PB# 89-19

DEIMER, WILLIAM SUBDIVISION #89-19
(3 lots)

TO: TOWN OF NEW WINDSOR BUILDING DEPT.
ATTENTION: MICHAEL BABCOCK, BUILDING INSPECTOR
FROM: RICHARD D. MC GOEY, P.E.
ENGINEER FOR THE TOWN
SUBJECT: APPLICATION FOR DEVELOPMENT IN A FLOOD HAZARD AREA
LANDS OF WILLIAM AND DOREEN DIEMER

SUBJECT: Diemer Lot Line Change & Minor Subdivision

SHEET NO. OF	LOT LINE CHANGE & MINOR SUBDIVISION FOR WILLIAM & DOREEN DIEMER
SCALE: 1" = 60'	TOWN OF NEW WINDSOR
DATE: 4-3-89	ORANGE COUNTY, NEW YORK
JOB NO. 89-21 DRAWN BY: J.F.	ZIMMERMAN ENGINEERING & SURVEYING, P.C.
ROUTE 17M HARRIMAN, NEW YORK 10926 PHONE (914) 782 7976

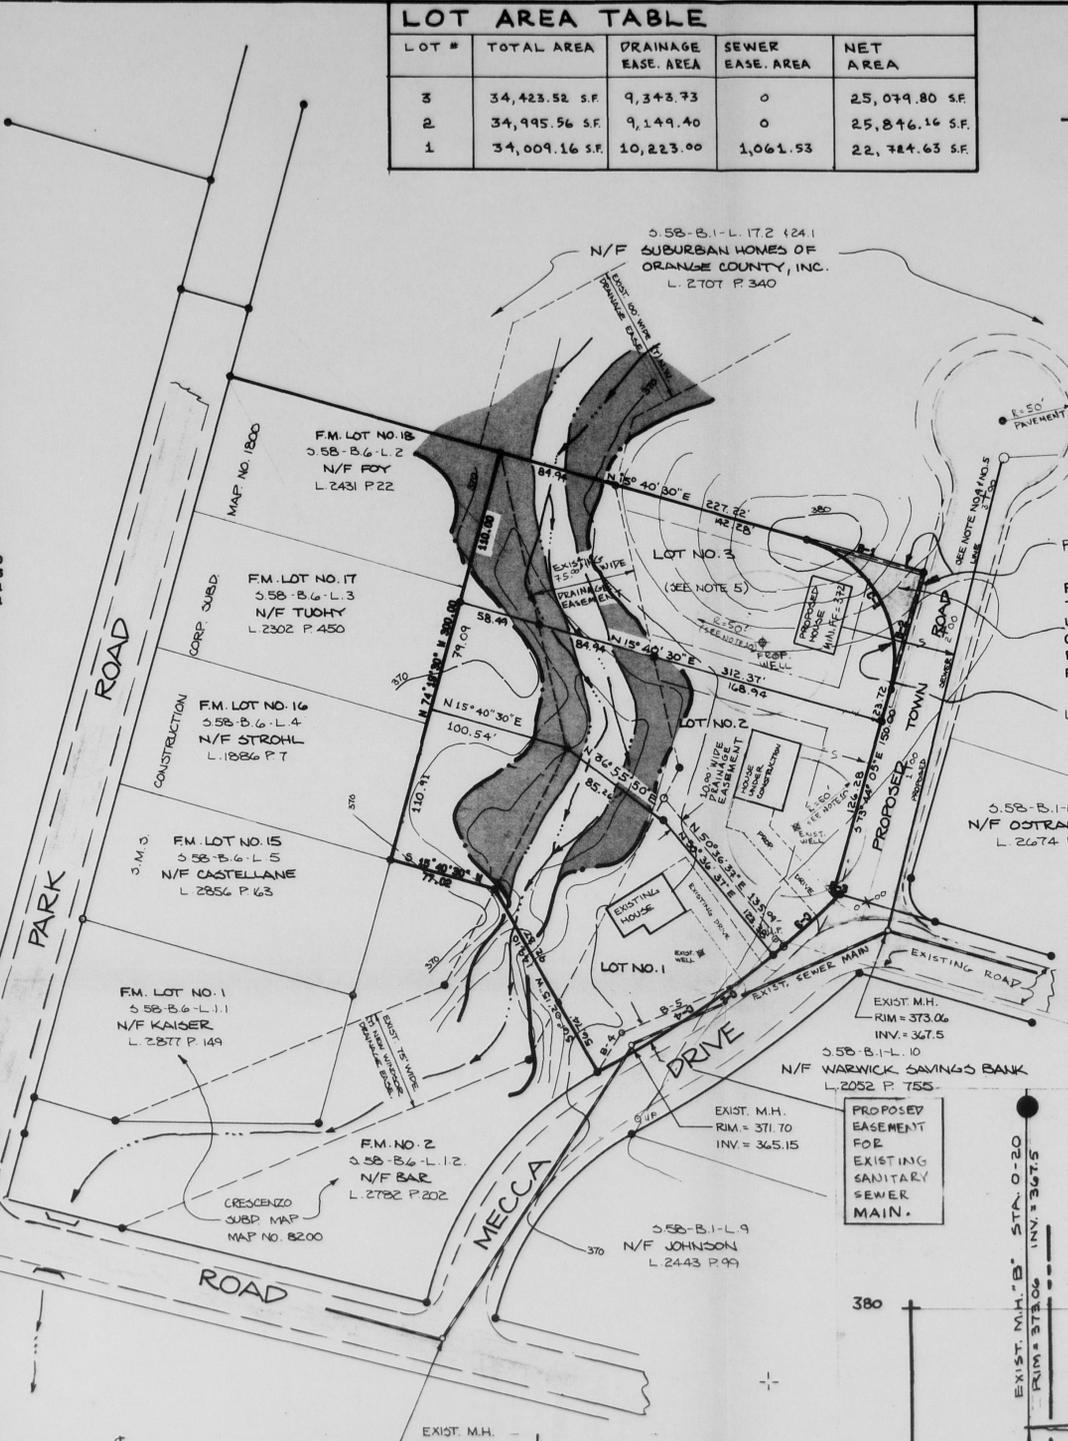
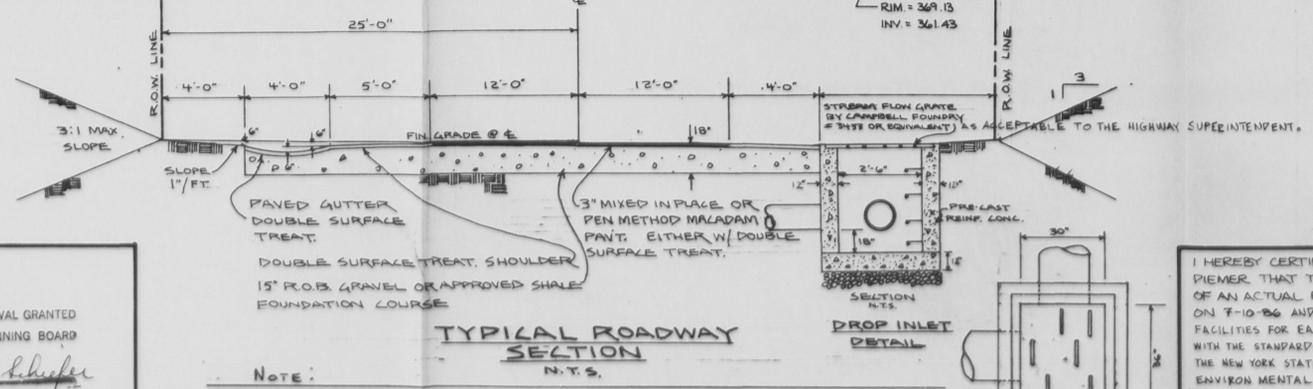
Mr. Soukup: Mark, on item 2, you say the plan appears to comply with the minor requirements of R4 zone. Does lot 2 have adequate frontage?

Mr. Edsall: Minimum is 60 foot and first off to step back a minute, they are indicating proposed road. I have to assume that this is in fact a correct statement that they intend to propose a road so you would not know that by looking at the map. We just heard that

tonight. The map indicates we are proposing a road. If they are not proposing a road, I'd suggest that they not allow this to be on the map. You shouldn't show a proposed road and in fact, it is proposed someplace else or by somebody else and even if that road doesn't go in, they have 64.44 feet so they would just meet the minimum requirements but I do take objection to the proposed road being shown when we were told tonight that it is not being proposed.

Mr. Soukup: I was curious about comment #7 about elevations. I think it would be a very good idea to show existing and proposed house elevations with respect to the drainage easement so we know there is no problem of future flood damage.

- a. A LOT AREA TABLE has been added to the plan. This table shows the total lot area, the lot area covered by easements and the net lot area free of easements.
- b. A proposed road cross section and profile are now provided. This information was taken from the plans for Subdivision Groves Homes, Inc.
- c. The lot lines involved in the lot line change are now clearly called out.
- d. The homes in the vicinity of this subdivision are served by town sewer facilities. The required separation between a well and watertight sanitary sewer lines is 50 ft., this information is now shown on the plan.
- e. As requested the Application for Development in Flood Hazard Areas is being submitted at this time.
- f. The table of bulk lot regulations has been expanded to include the requested values.
